COUNTY OF SAN MATEO PLANNING AND BUILDING

SUBJECT: Coastside Design Review Committee Continuance

APN 036-132-210; County File No. PLN 2019-00362

RE: Responses to Coastside Design Review Committee ("CDRC") Continuance

SE1

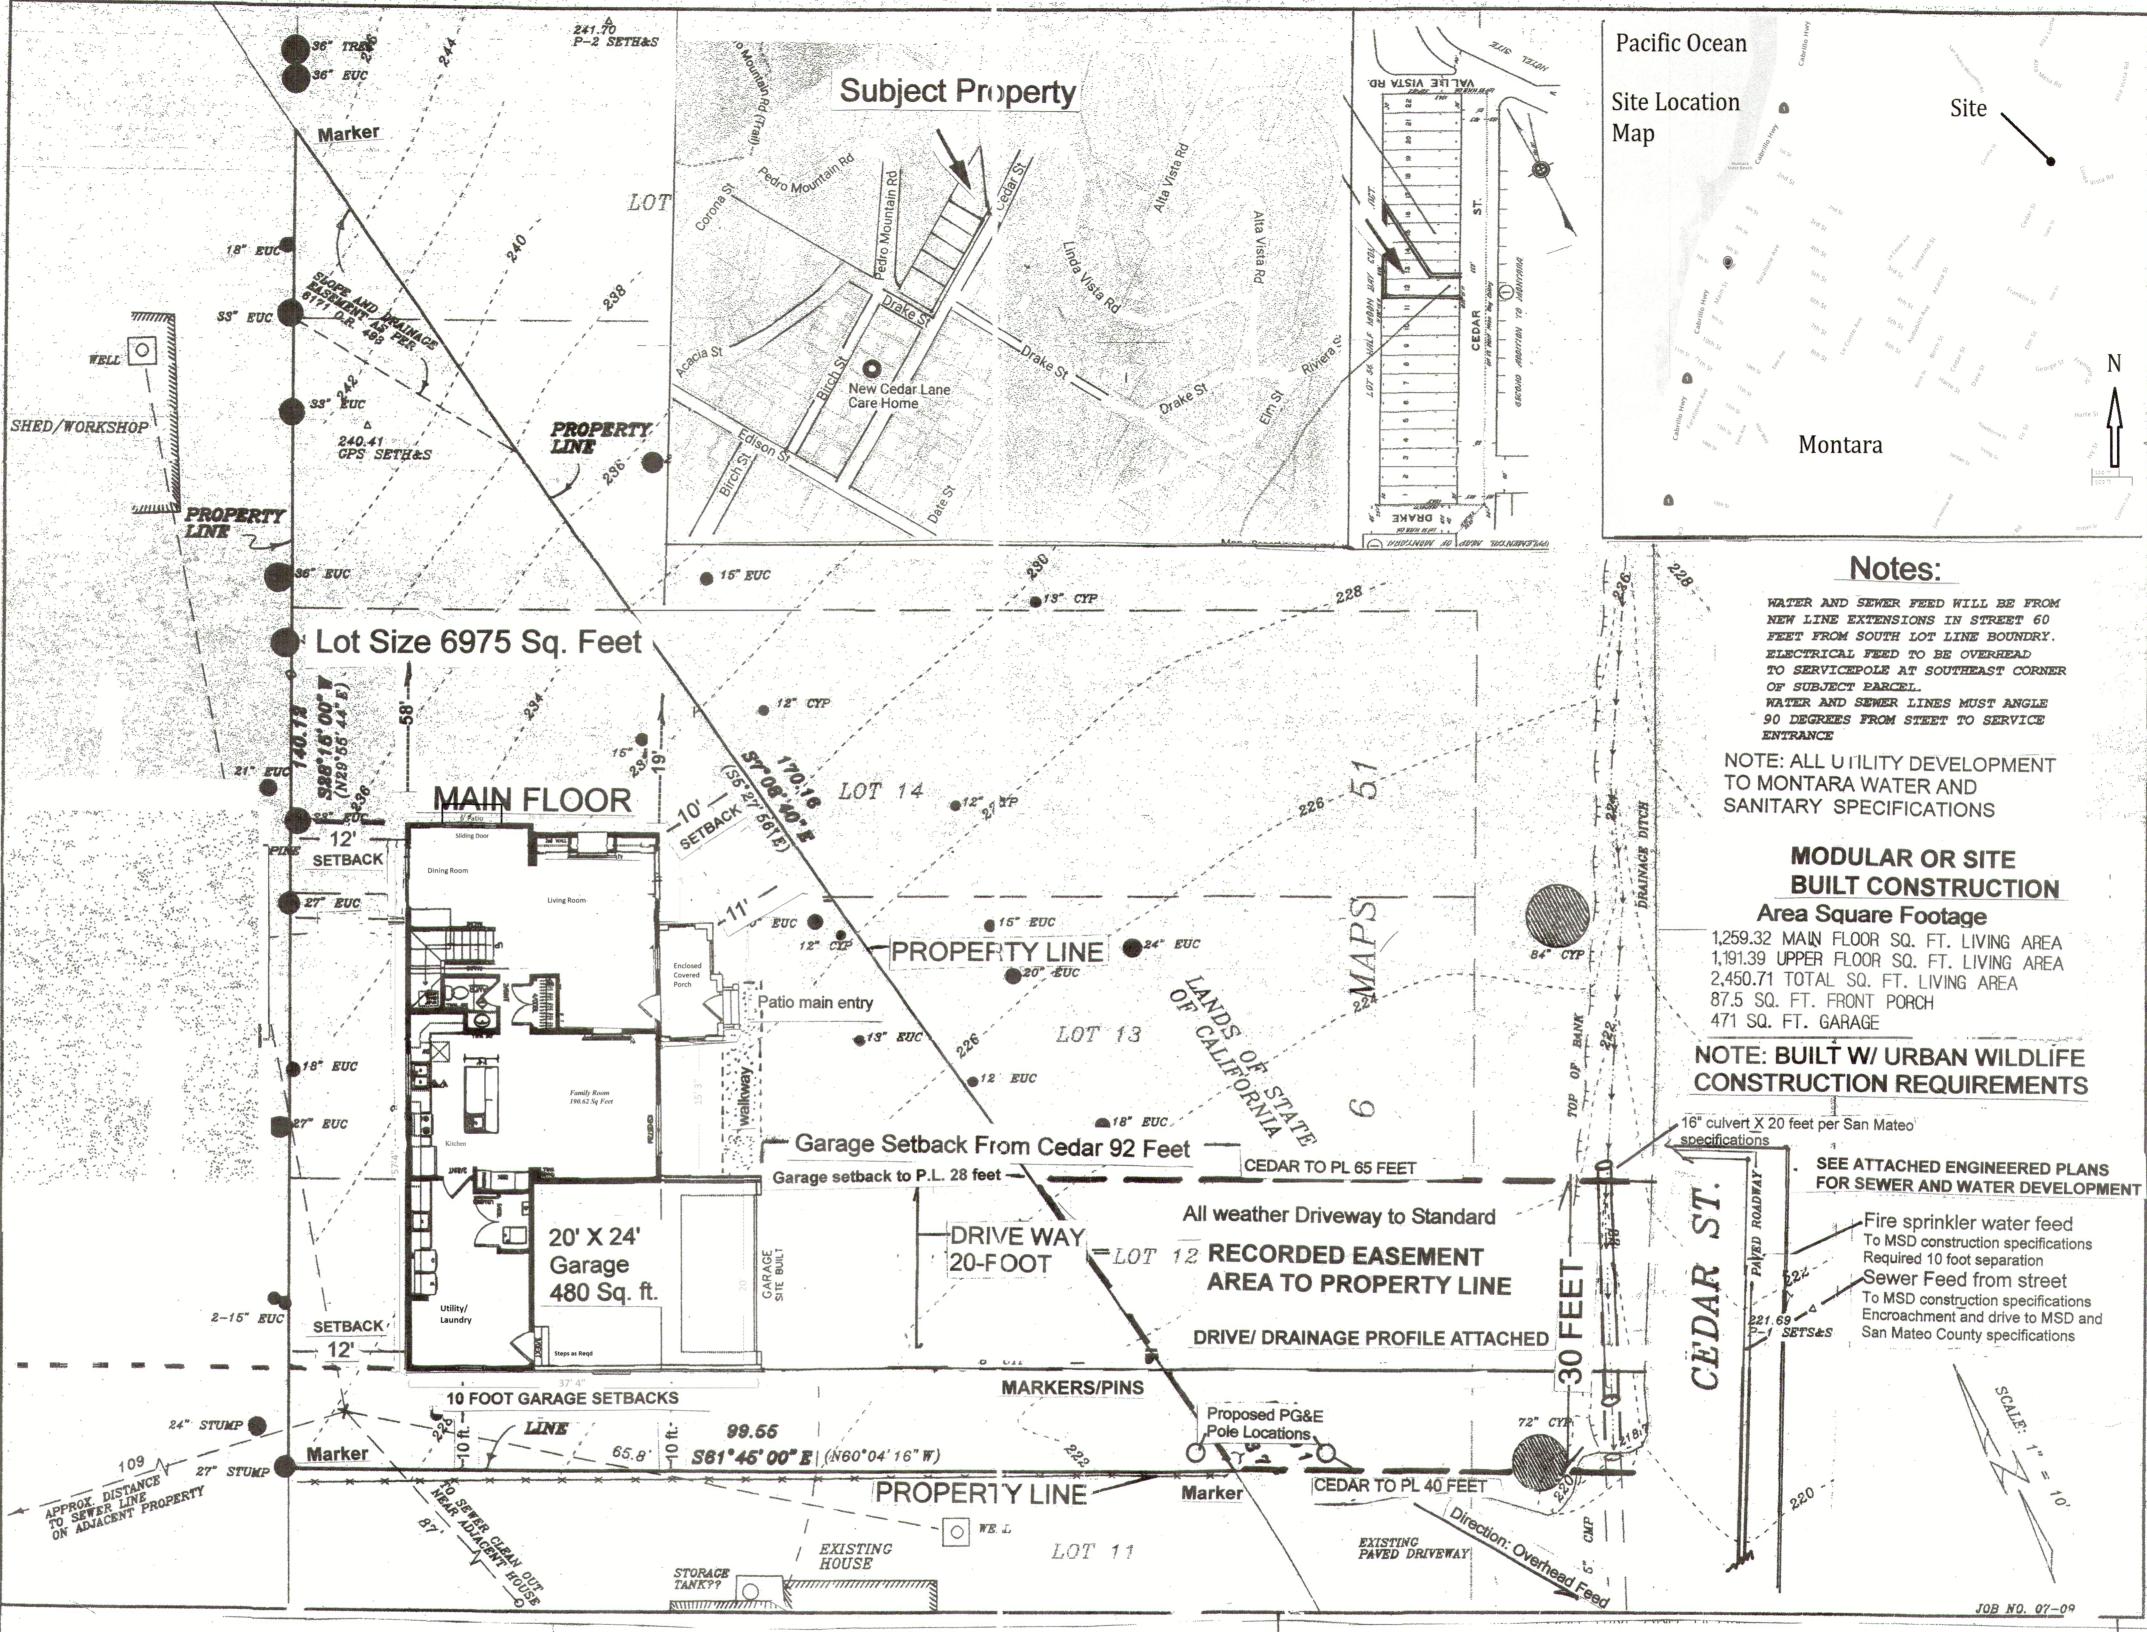
- 4. Section 6565.20(D) ELEMENTS OF DESIGN; 4. Exterior Materials and Colors; Standard c. Quantity: Use a number of exterior materials and colors that is consistent with the neighborhood and architectural style of the house. Encourage the use of three or more colors, colors on larger homes to reduce the appearance of bulk by emphasizing architectural features and trim. Discourage the use of a single exterior material or color in a large unbroken surface.

- 8. Materials (including lighting) and colors must be shown on a rendered drawing and elevations.
- 9. Note the North orientation on all drawings.
- 10. Update Code dates on Sheet C1 to show 2019 vs 2016.

Done. See SE 1 Color Rendering and SE 1 attachments for elevations and material samples.

Done. See SE 1 Color Rendering and SE 1 attachments for elevations and material samples.

SHEET TITLE
FIRST FLOOR
ELECTRIC PLAN
DRAWING NUMBER

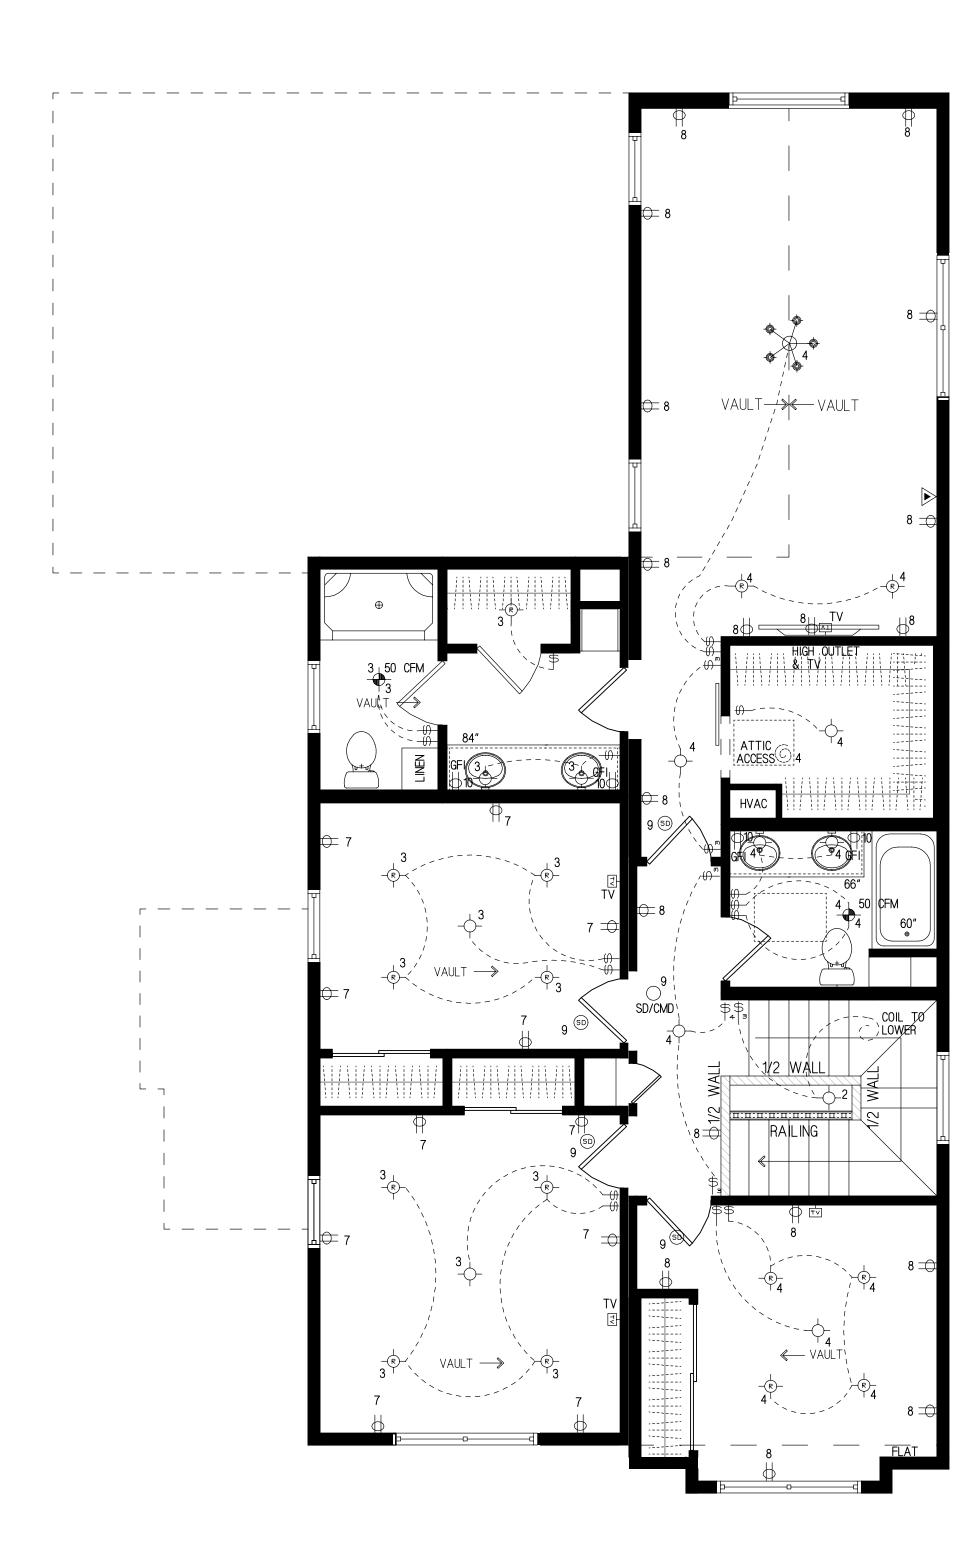
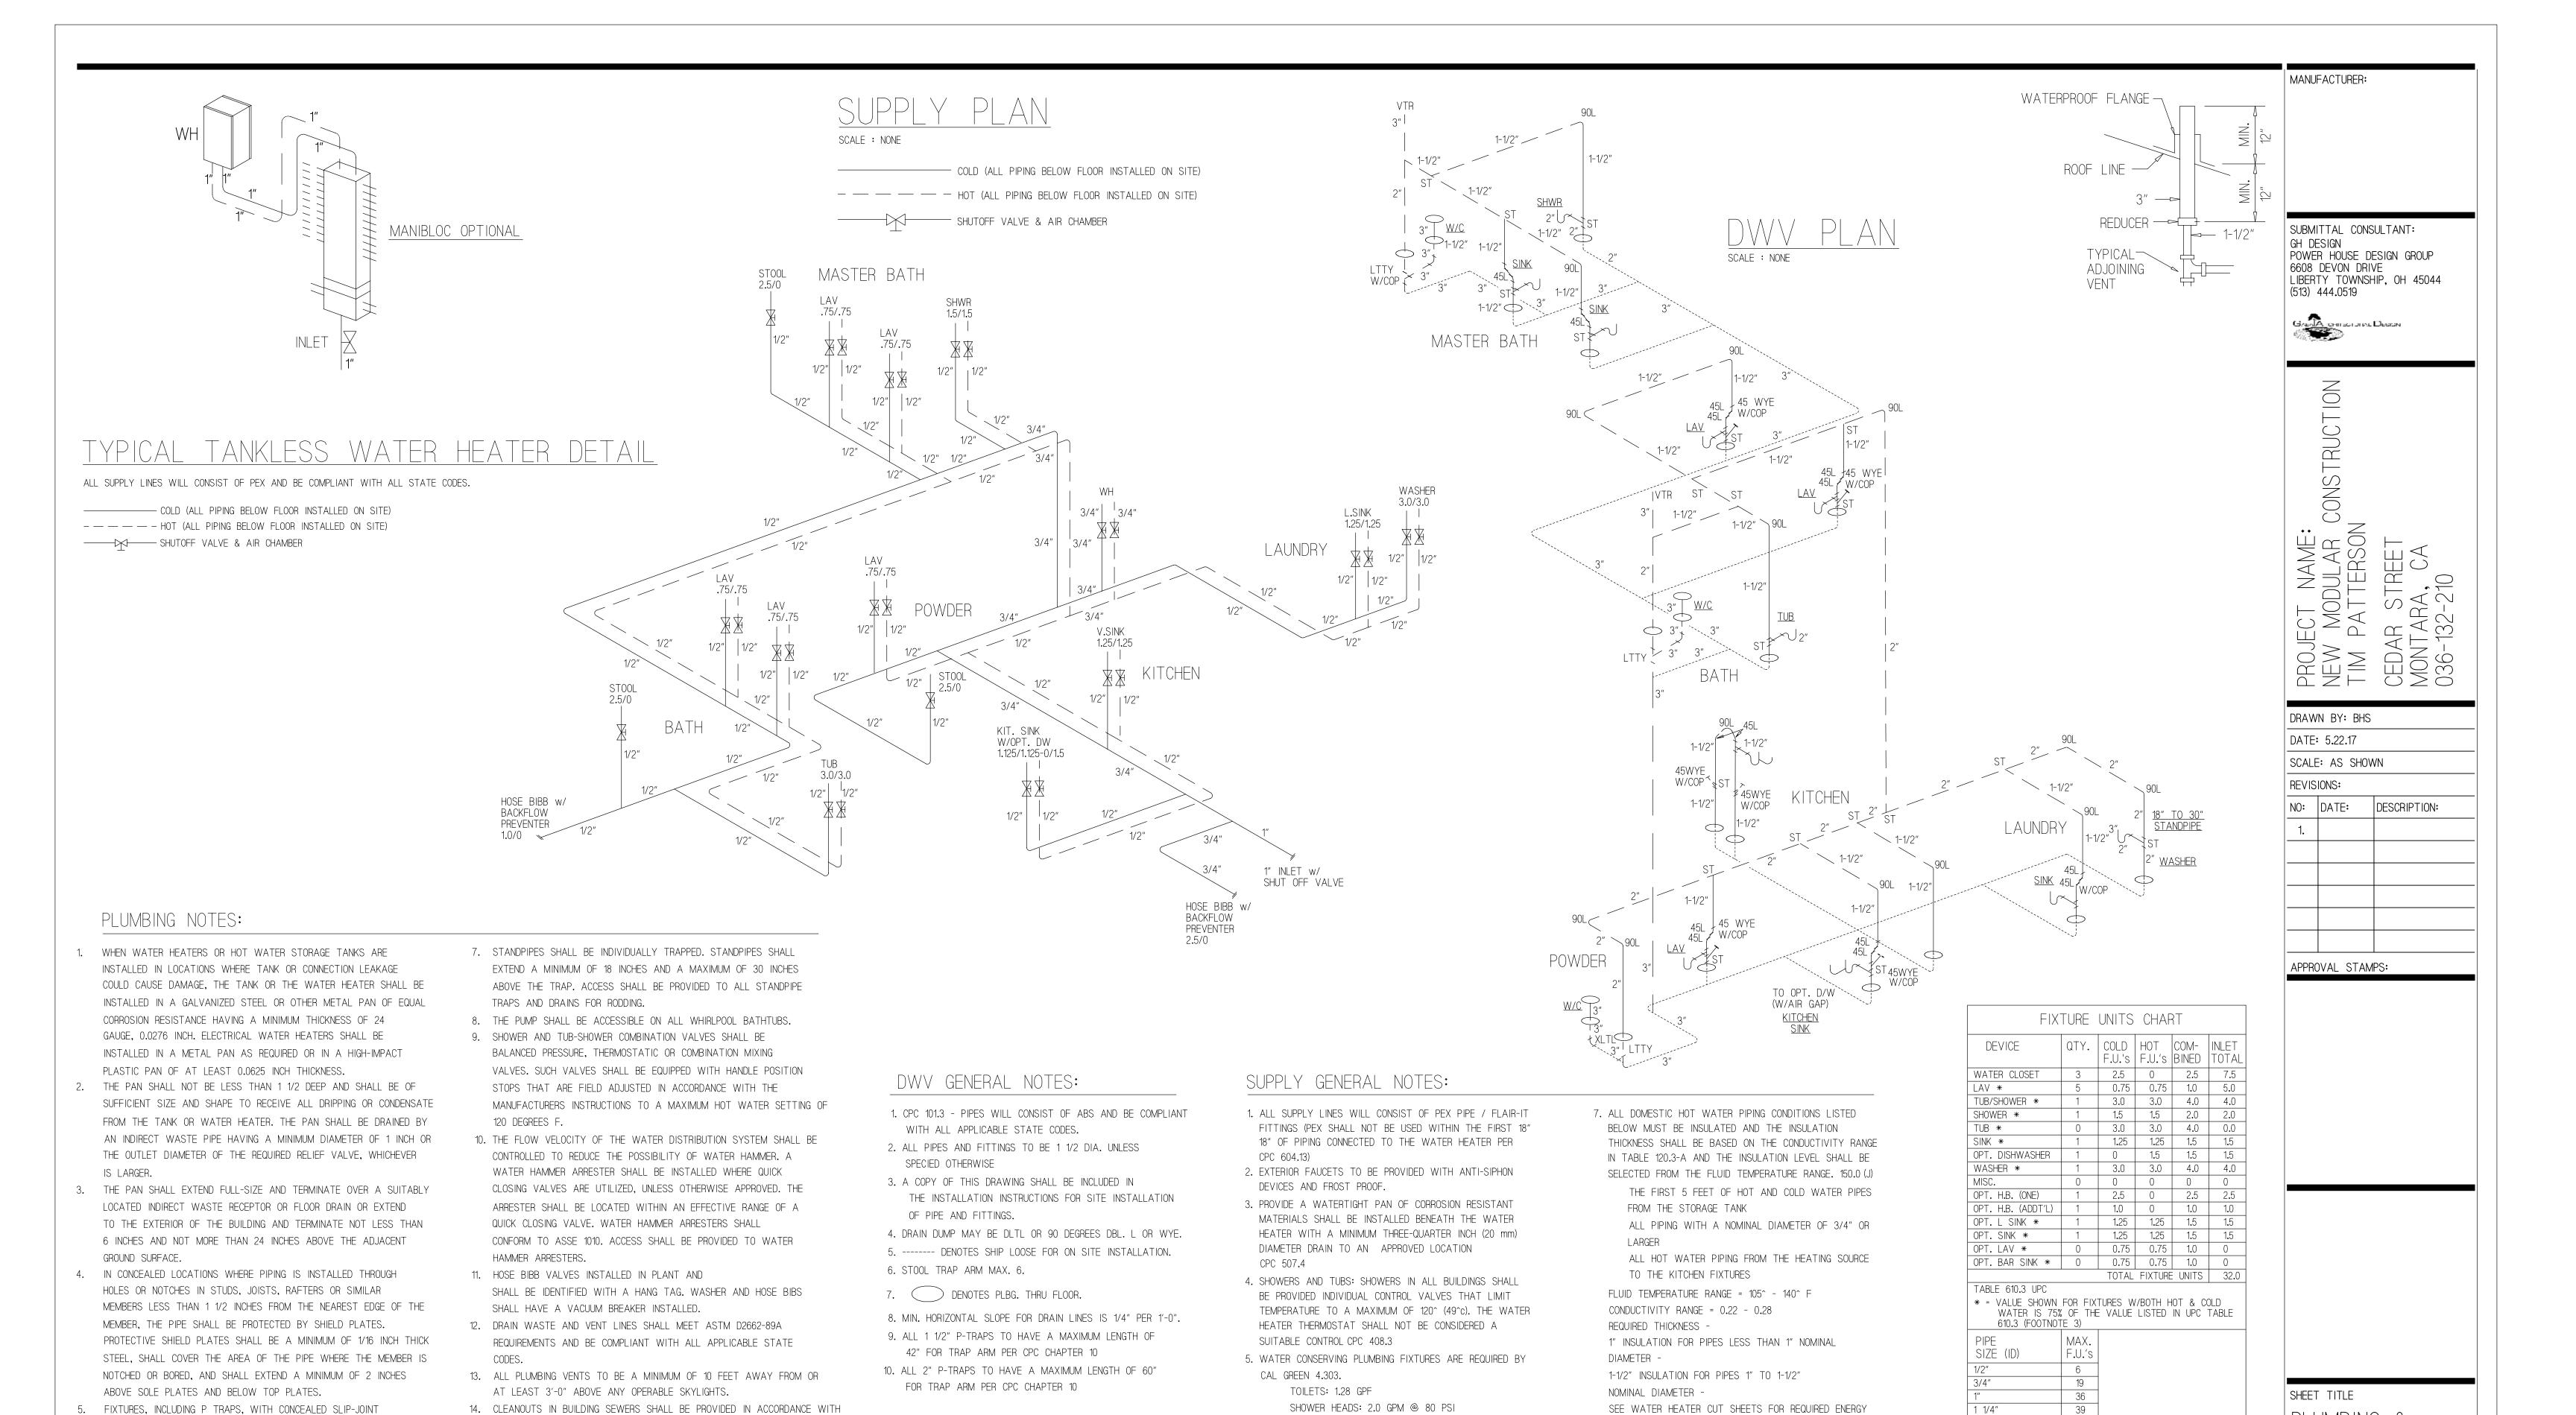
- 11. Show Front Porch Sconce on Architectural Elevation Sheet E1, as indicated on Electrical Sheet EL1.
- 12. Show Garage Door Lite on Electrical Sheet E1, as indicated on Architectural Elevation Sheet E1.

Done. Front Porch Sconce has been added to all drawings.

Done. Garage Door Lite is on Electrical Sheet E1.
